## Product Change Notification - SYST-21EDWO528

ERRATA - PIC32MX1XX/2XX/5XX 64/100-pin Family Silicon Errata and Data Sheet Clarification

## PIC32MX1XX/2XX/5XX 64/100-pin Family Silicon Errata and Data Sheet Clarification

## 17. Module: I/O Port - Initial Pin State

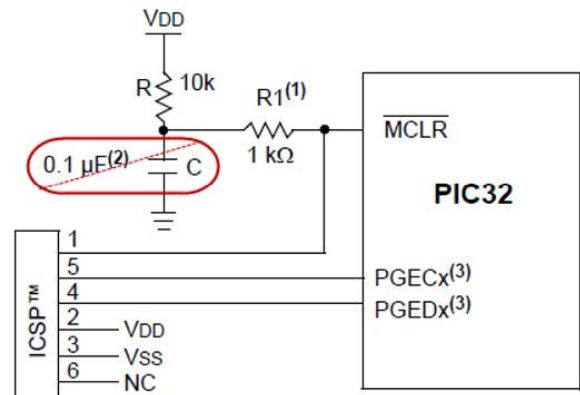
On power-up depending on the VDD ramp rate, the I/O pins can be in an active random output driving state if  $\overline{\text{MCLR}}$  is active until a BOR event.

If, not using an external reset supervisor IC or equivalent, remove the  $\overline{\text{MCLR}}$  capacitor as shown below, and retain the  $\overline{\text{MCLR}}$  Pull-up resistor.

If using an external reset supervisor IC or equivalent, increase the value of the VCAP capacitor to  $\geq 47 \mu\text{F}$  ceramic or solid tantalum capacitor with an ESR  $\leq 1 \text{ ohm}$ .
